United States Patent and Trademark Office

APPLICATION NO.	F	ILING DATE	FIRST NAMED INVENTOR	ATTORNEY DOCKET NO.	CONFIRMATION NO.
10/821,298	821,298 04/09/2004		James R. Mujwid	75028-307907	1231
43541	7590	06/22/2006		EXAMINER	
•		& EVANS	ARAJ, MICHAEL J		
ATTN: PA	TENT DO	CKETING			
2700 CARI	EW TOWE	ER	ART UNIT	PAPER NUMBER	
441 VINE S	STREET		3733		
CINCINNA	TI, OH	45202

Annication No.	Amelianati					
	Application No.	Applicant(s)					
Office Action Summary	10/821,298	MUJWID ET AL.					
Onice Action Summary	Examiner	Art Unit					
The MAILING DATE of this communication and	Michael J. Araj	3733					
The MAILING DATE of this communication appears on the cover sheet with the correspondence address Period for Reply							
A SHORTENED STATUTORY PERIOD FOR REPLY IS SET TO EXPIRE 3 MONTH(S) OR THIRTY (30) DAYS, WHICHEVER IS LONGER, FROM THE MAILING DATE OF THIS COMMUNICATION. - Extensions of time may be available under the provisions of 37 CFR 1.136(a). In no event, however, may a reply be timely filed after SIX (6) MONTHS from the mailing date of this communication. - If NO period for reply is specified above, the maximum statutory period will apply and will expire SIX (6) MONTHS from

Figure 1 (modified from 5,797,918)

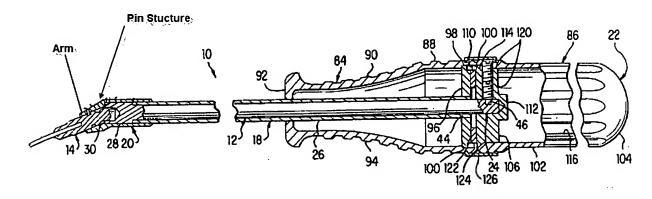
Claims 1-9, 15-21 and 31-36 are rejected under 35 U.S.C. 102(b) as being anticipated by McGuire et al. (U.S. Patent No. 5,797,918).

McGuire et al disclose a surgical driver comprising an attachment piece having mounting structure, a shaft connected to the attachment piece (14) by a coupling arrangement being configured to transfer torque from the shaft to the attachment piece and permit the shaft to pivot relative to the attachment piece in a range of 1-30 degrees in any direction. The coupling arrangement includes one or more facets formed at a distal end of the shaft that permit the shaft to pivot in a range of axial orientations relative to a longitudinal axis of the attachment piece. The facets are located adjacent to a base of a knob (20). The coupling arrangement includes a recess formed in the attachment piece, the recess being configured to receive a distal end of the shaft. The attachment piece further includes a retaining member, and wherein at least a portion of the retaining member is positioned within the recess to detachably connect the shaft to the attachment piece. The attachment piece includes self-centering structure that axially aligns the shaft with the attachment piece when the shaft is initially connected to the attachment piece because of the shape of the attachment piece when it is attached to the shaft. This device further including a handle coupled to a proximal end of the

shaft. The mounting structure of the attachment piece includes a pin structure having arms that extend outward from a distal end of the attachment piece wherein the arms provide a snap-fit connection (see Figure 1 below).
